Appendix D LUL Correspondence

From:Howard Malcolm < Malcolm.Howard@tube.tfl.gov.uk>Sent:29 October 2020 10:03To:Francesc MiradaCc:Paul MorrisonSubject:RE: [External] RE: 5-17 Haverstock Hill GI

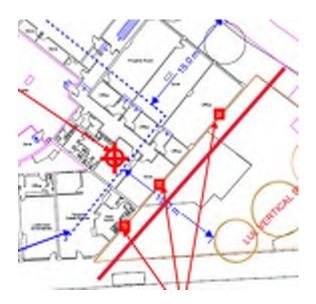
Looking at the CAD survey data (previously provided) the edge of Chalk Farm station is closer than you have shown.

You have placed a 15.0m exclusion zone to the vertical shafts but you don't seem to have shown the edge of the station structure or it's distance.

This is **<u>much</u>** closer to the boundary of your site.

Please see below. I've marked up the 'Ticket Hall and Rooms' from the CAD data.

Can I ask you to consider the edge of the station and amend the location of the borehole accordingly please.
